IEAPM Ref: 2026-02-L2

IEAPM Advice on Hunter Valley Operations Continuation Project (SSD-11826681 and SSD-11826621)

On 10 December 2025, the NSW Department of Planning, Housing and Infrastructure (DPHI) requested the Independent Expert Advisory Panel for Mining (IEAPM, 'the Panel') to provide advice in relation to the two amended applications by HV Operations ('HVO') (SSD-11826681 and SSD-11826621).

Figure 1: Highlighted figure taken from Appendix E Greenhouse gas assessment (Aug. 2025; figure 3.12) with Scope 1 CO₂-e emissions.

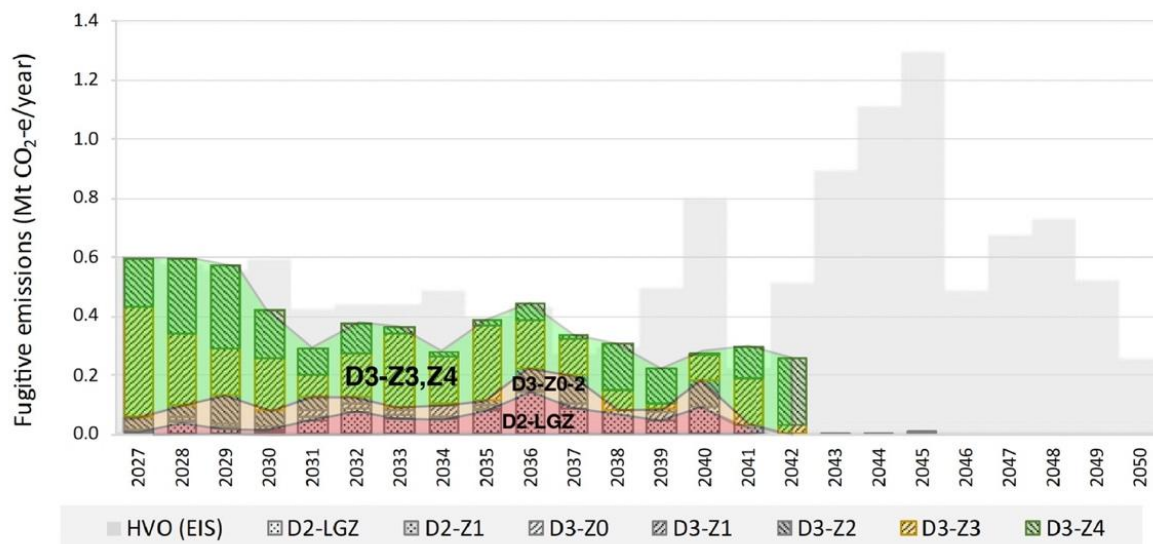
The Panel notes that mining in the higher gas zones of Domain 3 will occur in the period 2027 to 2029 (see Fig. 1 above), so *high priority needs to be given to the PFS*. In this regard, the Applicant should include in the PFS the proposed pathway and a schedule to potentially drain these higher gas zones.

The Panel recommends that should the project be approved, the intended pre-drainage trial scope and schedule be determined by way of a written plan and is agreed upon to the satisfaction of the Planning Secretary. It should consider the various issues raised by CoalBed's 2023 study, as well as the enhancement of permeability due to overburden removal and any learnings from open cut pre-drainage trials undertaken either at site or by industry elsewhere over the last 2 years. A prefeasibility scope is not onerous and the Panel recommends submission to DPHI within 2 months after determination.

The Panel recommends approval conditions should require an independent expert review of the actual prefeasibility report, to the satisfaction of the Planning Secretary.
